ECE/TRANS/WP.29/2007/29
5 April 2007

Proposal for Supplement 7 to Regulation No. 110
(Specific components for CNG)

Submitted by the Working Party on Pollution and Energy (GRPE)

Fig. 1: 20 MPa Filling unit (receptacle) for M₁ and N₁ vehicles

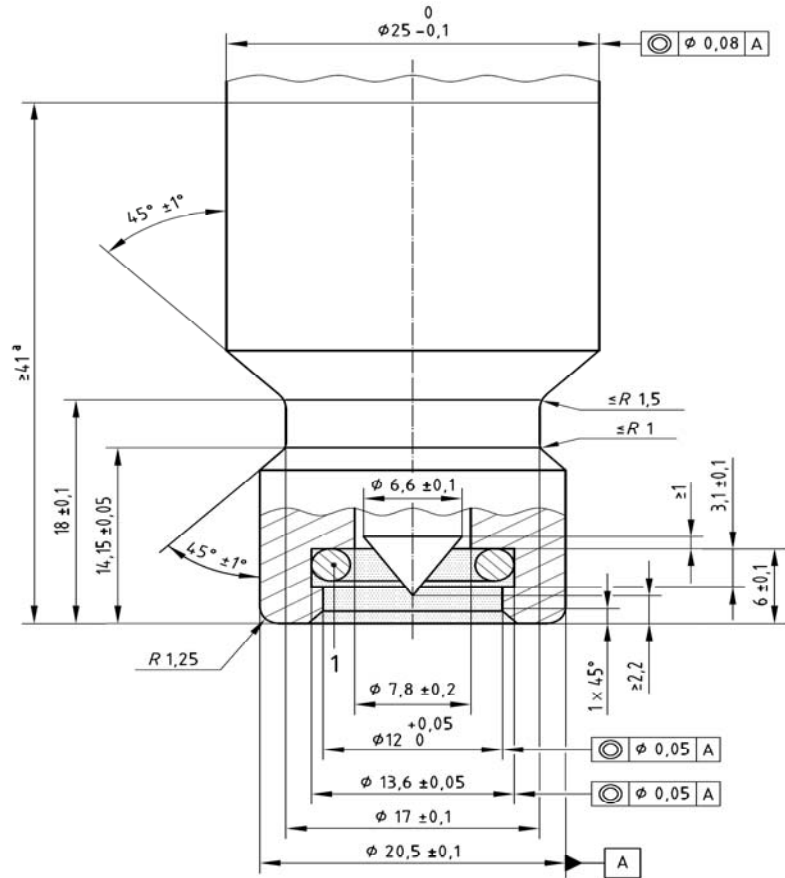
Annex 4F, amend to read:

4.1. Figure 1 shows the dimensions of the filling unit for vehicles of categories M₁ and N₁. 2/

This area shall be kept free of all components.

1 Sealing surface equivalent to No. 110 O-ring of dimensions:

9.19 mm ± 0.127 mm ID

2.62 mm ± 0.076 mm width

Sealing surface finish: 0.8 μm to 0.05 μm

Material hardness: 75 Rockwell (HRB 75) minimum

a Minimum length of the receptacle which is clear of provisions for attachment of receptacle or protective caps.
